ITEM FOR ENVIRONMENTAL COMMISSION AGENDA

NAME & NUMBER OF PROJECT: SP-2019-0032D Oaks at Slaughter Site Improvements

REQUEST: Variance request is as follows:
Request to vary from LDC 25-8-341 to allow cut more than four feet of depth

STAFF RECOMMENDATION: Staff does not recommend this variance, having determined that the findings of fact have not been met.

Title
CUT FILL ANALYSIS

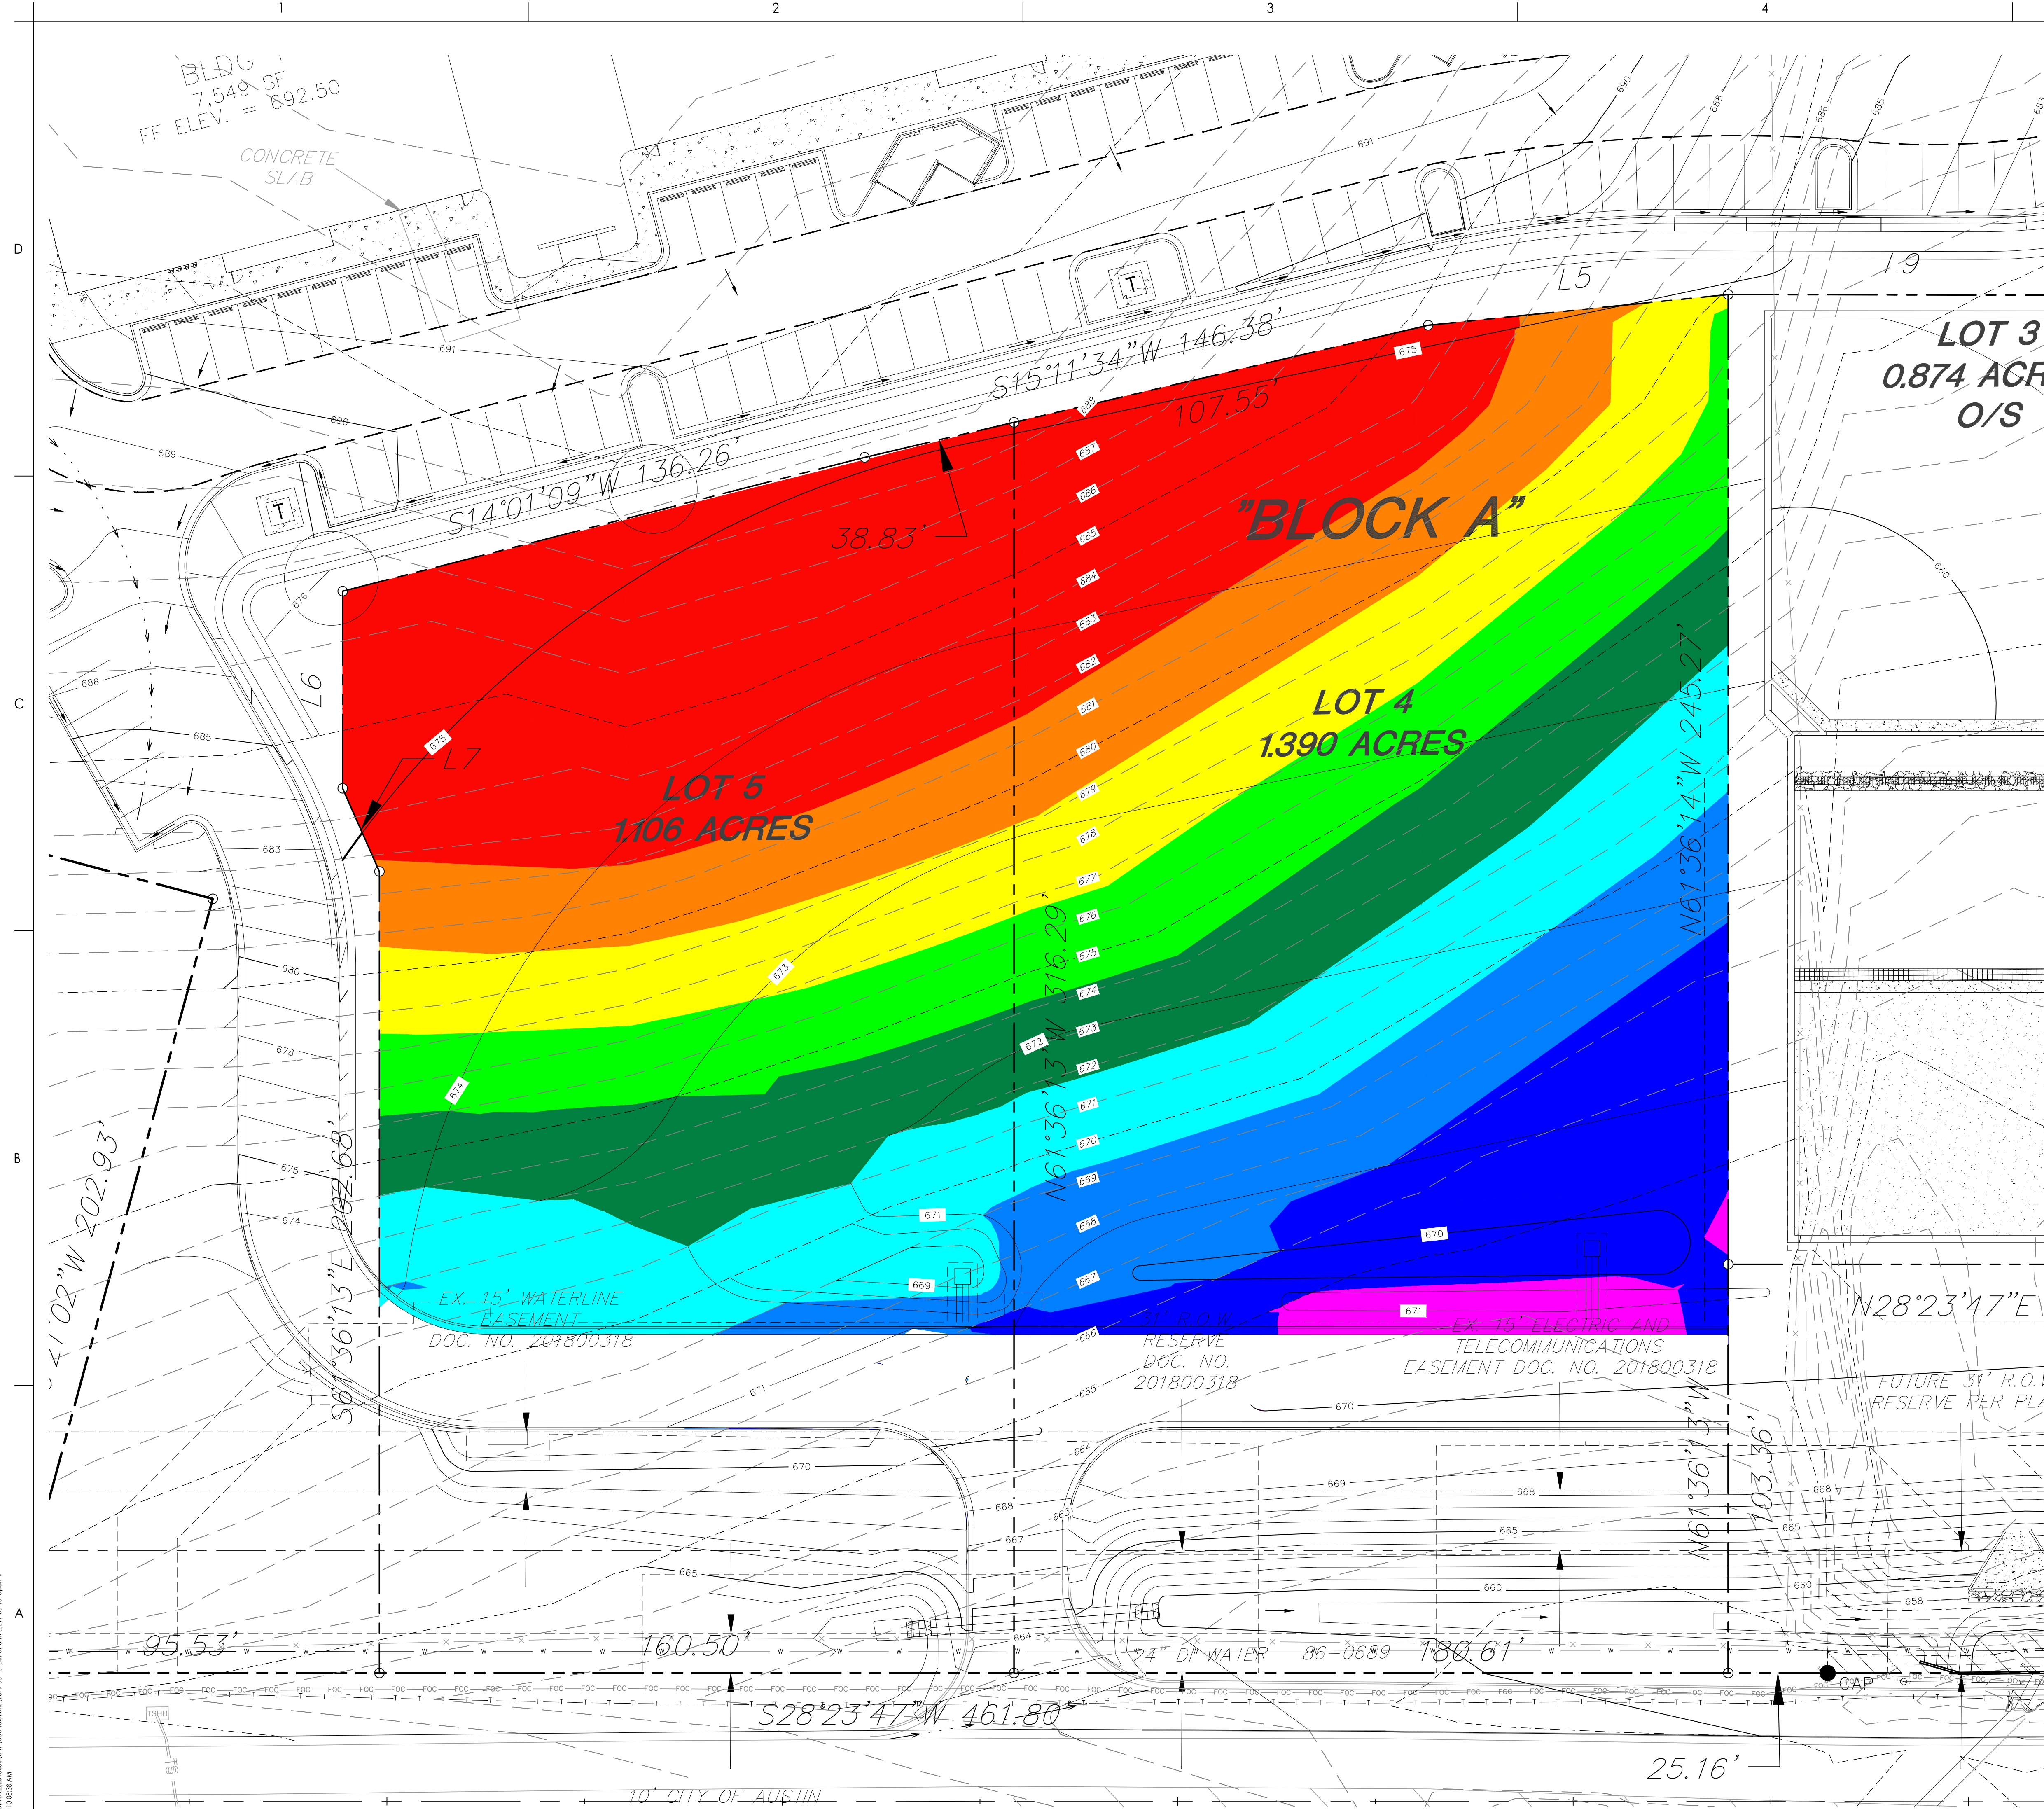
No. The proposed grading is a design decision made by the applicant to “pad prep” an area of undeveloped land for future development. The future development of the property is unknown at this time, the applicant has not submitted a site plan application showing proposed buildings or other associated improvements.

No. An administrative environmental variance may be granted for cut of no more than eight feet in the desired development zone [LDC 25-8-42(B)(6)], however, the proposed cut is in excess of

what can be allowed with an administrative environmental variance; to a depth of 13 feet.

No. The proposed cut will remove existing trees that meet preservation criteria of LDC 25-8-624, as well as alter existing drainage patterns and existing vegetative cover.

<p>Clearly indicate in what way the proposed project does not comply with current Code (include maps and exhibits)</p>	<p>The project proposes cut greater than 8 feet, with a maximum cut of 11 feet (please reference attached exhibit for detailed cut/fill data) for the following reasons:</p> <ol style="list-style-type: none"> 1. Pedestrian Accessibility <ol style="list-style-type: none"> a. This cut variance will be required in order to comply with the regulations set by Texas Accessibility Standards which require a 2% maximum slope across parking spaces and accessible route between said spaces and building entrance. b. This site has been designed with a maximum slope in order to provide easier customer access to the site using all modes of transportation. 2. Pedestrian Safety <ol style="list-style-type: none"> a. This design allows for proper access for fire trucks and other emergency vehicles which promotes the health and safety of all visitors to the site, while complying with the requirements set forth by the Land Development Code. b. With the design slope proposed in the parking area, car doors won't hit nearby pedestrians or cars. 3. Construction Logistics <ol style="list-style-type: none"> a. This site design will allow better grade tie in points with the proposed grades create by the Oaks at Slaughter Construction Plans (C8-2018-0109-1B), which were created in order to comply with the minimum cover requirements over the proposed utilities. <p>Please reference exhibits provided at the end of this document.</p>
